UNITED STATES PATENT AND TRADEMARK OFFICE

APPLICATION NO.	FILING DATE	FIRST NAMED INVENTOR	ATTORNEY DOCKET NO.	CONFIRMATION NO.
10/827,407	04/17/2004	Shu-Lien Tang	P03211-F001	2593
7590		01/11/2007		
Tang, Shu-Lien				
7F., No. 213				
Civic Boulevard. Sec. 4				
Taipei, 105				
TAIWAN				
		EXAMINER		
		MERCADO, JULIAN A		
		ART UNIT		PAPER NUMBER
		1745		
SHORTENED STATUTORY PERIOD OF RESPONSE		MAIL DATE		DELIVERY MODE
3 MONTHS		01/11/2007		PAPER

Office Action Summary

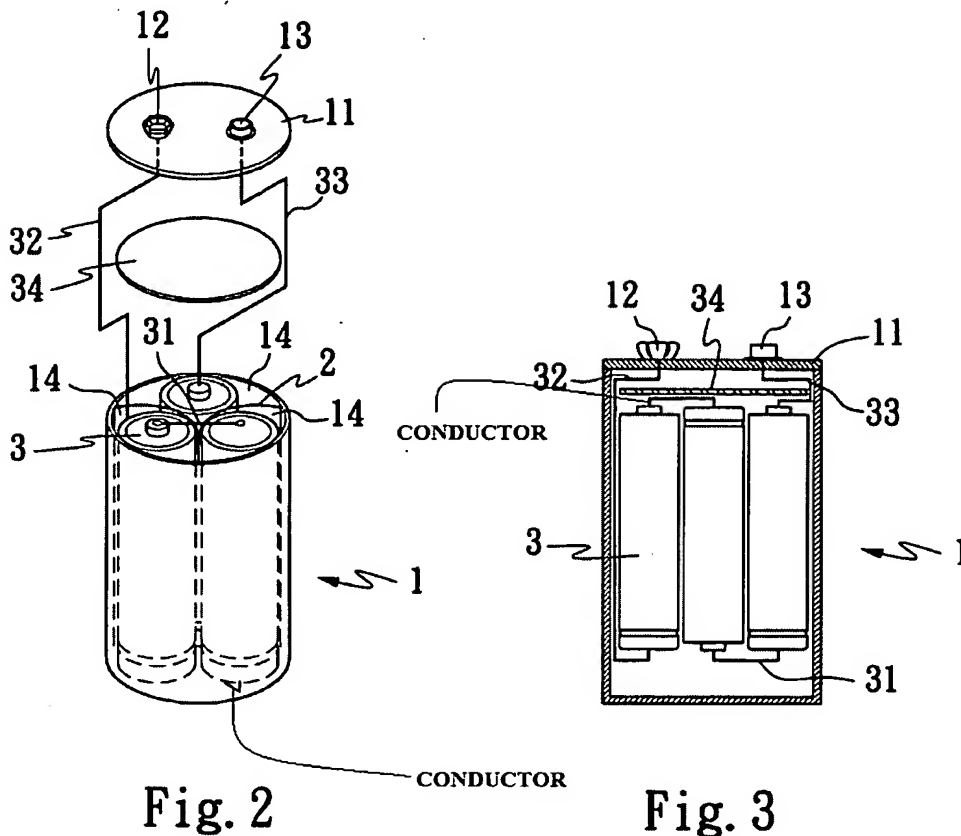
The drawings are objected to because the conductors [31], [32] and [33] appear to remain as a open circuit even when connected to a load. See Figure 3 in comparison to Figure 2 with attention to conductor [32]. In Figure 3, note that conductor [31] is shown to connect the second and third batteries, while in Figure 2 the same conductor is shown to connect the first and second batteries. It appears to the examiner that Figure 3 should show all connection points since the Figure is a cross-section. Optionally, Figure 2 should also show the connection points, while it is understood as less important since this Figure is a perspective view and the connection may be hidden in the drawings. The examiner has attached herein suggested modifications for the drawings, labeled with "CONDUCTOR".

Claim 1 at lines 8-10 (corresponding to lines 10-12 of page 9) recites a first conductor connecting all three batteries. In view of Figure 3 and its accompanying description on page 6, it is unclear how a single conductor physically connects all three batteries. For purposes of examination, while it is understood that all three batteries are connected, the first conductor is interpreted to connect two of the three batteries.

Corrected drawing sheets in compliance with 37 CFR 1.121(d) are required in reply to the Office action to avoid abandonment of the application. Any amended replacement drawing sheet should include all of the figures appearing on the immediate prior version of the sheet, even if only one figure is being amended. The figure or figure number of an amended drawing should not be labeled as "amended." If a drawing figure is to be canceled, the appropriate figure must be removed from the replacement sheet, and where necessary, the remaining figures must be renumbered and appropriate changes made to the brief description of the several views of the drawings for consistency. Additional replacement sheets may be necessary to show the renumbering of the remaining figures. Each drawing sheet submitted after the filing date of an application must be labeled in the top margin as either "Replacement Sheet" or "New Sheet"
